ANCHOR BOLT SETTING PLAN
(BOTTOM OF BASE PLATE ELEVATION: (-1'-10") (U.N.O)
(REF:S1.1)

07/24/2020			ISSUE FOR APPROVAL
DATE	NO.		DESCRIPTION
REVISIONS

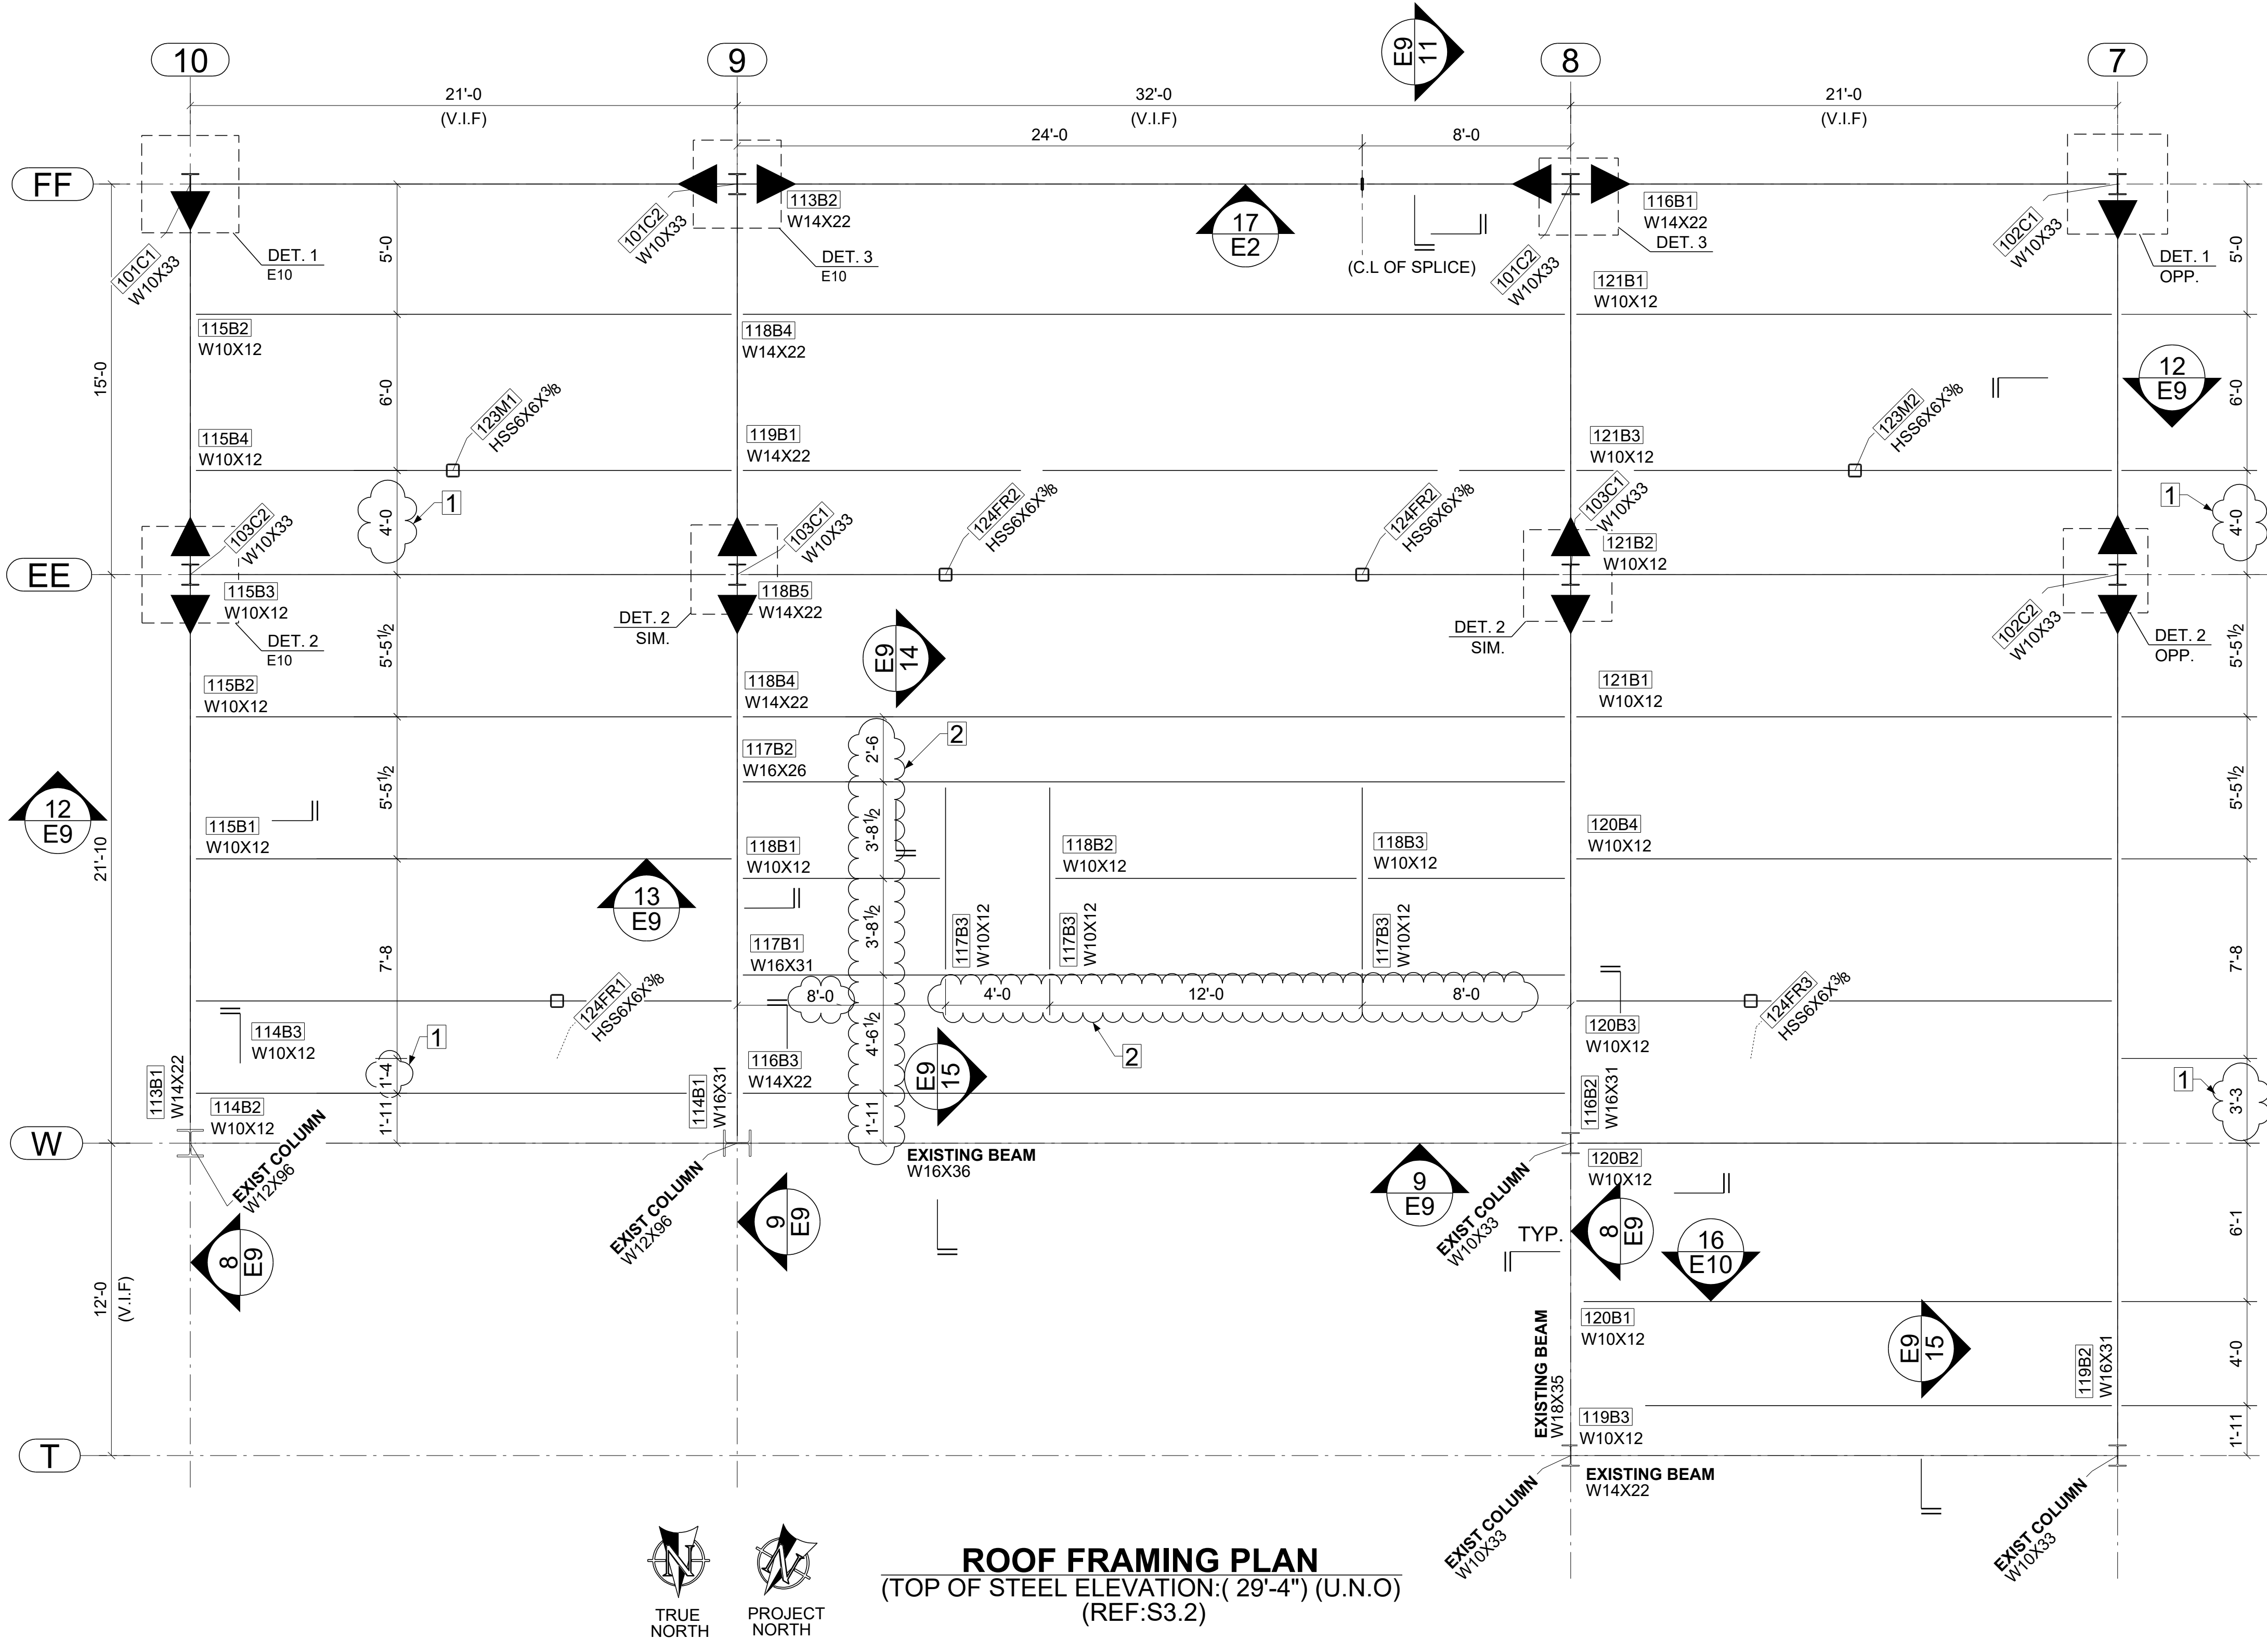
- 1 PLEASE REVIEW AND CONFIRM THE CLOUDED ROOF SCREEN WALL PART LOCATION AND HENCE CONFIRM THE CLOUDED BEARING BEAM LOCATIONS FOLLOWED ARE ACCEPTABLE.
- 2 PLEASE REVIEW AND CONFIRM THE CLOUDED CURB SUPPORT BEAMS LOCATING DIMENSIONS FOLLOWED.

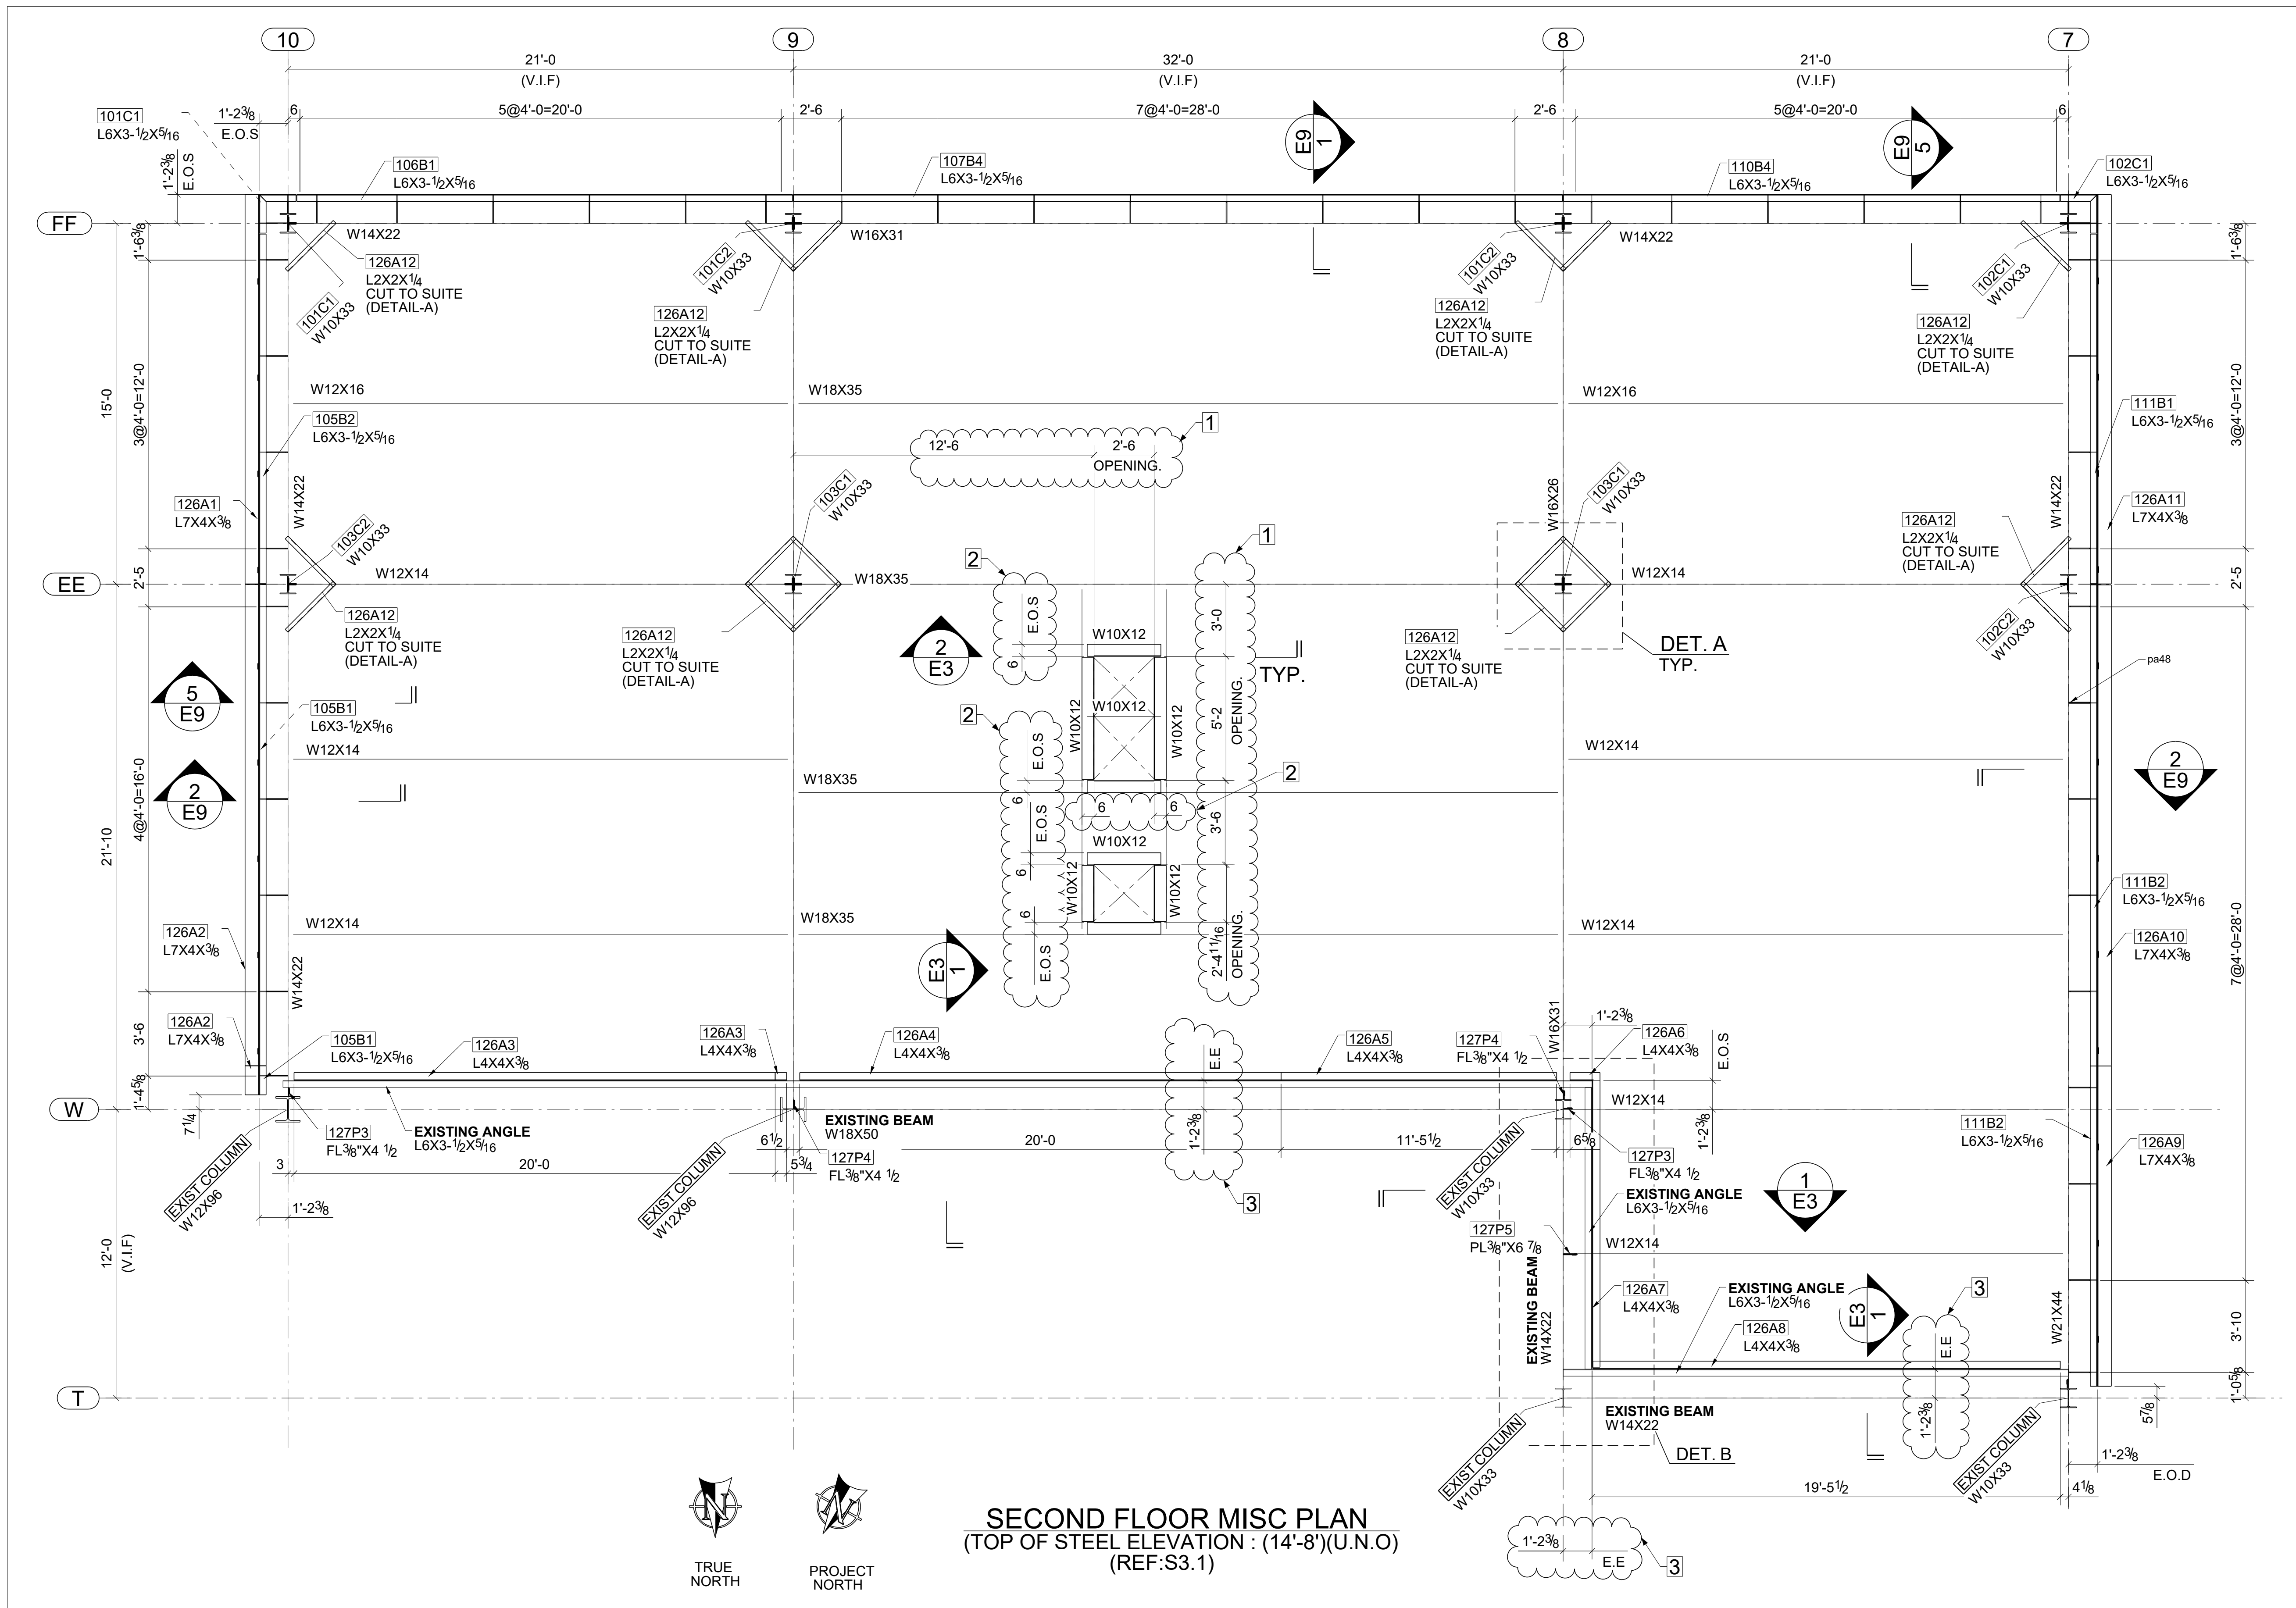
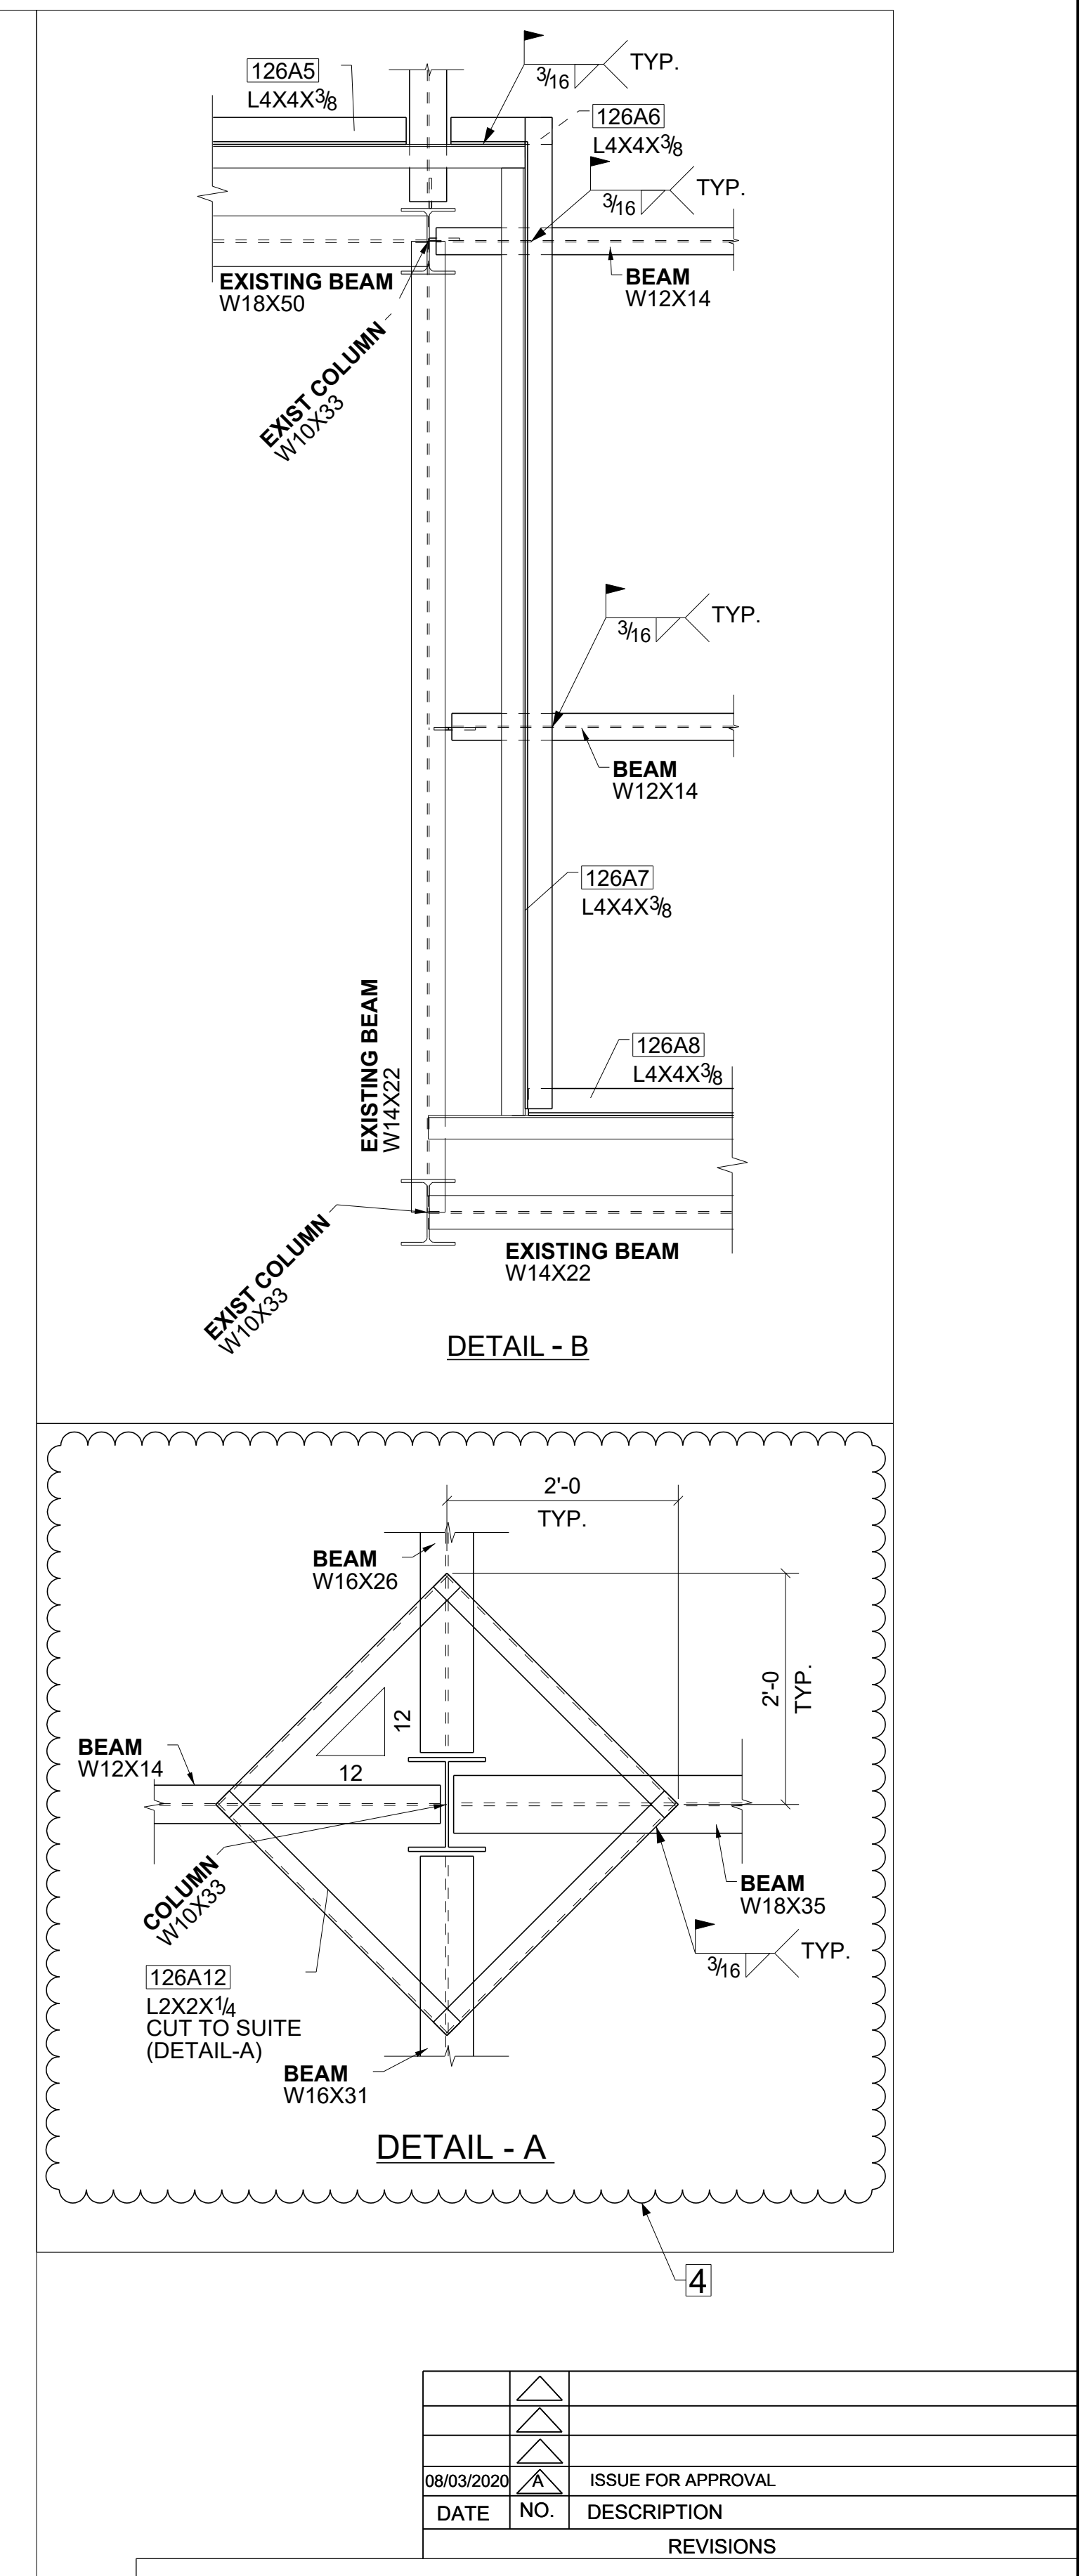
- PLEASE REVIEW AND CONFIRM THE CLOUDED OPENING LOCATIONS AND SIZES FOLLOWED.
- PLEASE REVIEW AND CONFIRM THE CLOUDED 6" E.O.S DIMENSION FOLLOWED WITH 1/4" EDGE OF SLAB BENT PLATES.
- PLEASE REVIEW AND CONFIRM THE EXISTING EDGE OF SLAB DIMENSIONS FOLLOWED.
- PLEASE REVIEW AND CONFIRM THE CLOUDED DECK SUPPORT ANGLES ARRANGEMENT AT COLUMNS FOLLOWED.
- PER DETAIL 13/S4.2 IT IS SHOWN THAT THE THREADED ROD IS WELEDED TO EXISTING EOS BENT PLATE AND IT SHOULD BE BOLTED TO ATTACH THE NEW EOS ANGLE, BUT INSTEAD OF FILED WELDING THE RODS TO THE EXISTING EOS AND BOLTING THEM, WEARE DIRECTLY FIELD WELDING THE MEW EOS ANGLE TO EXISTING POURSTOP AS CLOUDED. PLEASE REVWIW AND CONFIRM OR ADVISE OTHERWISE.
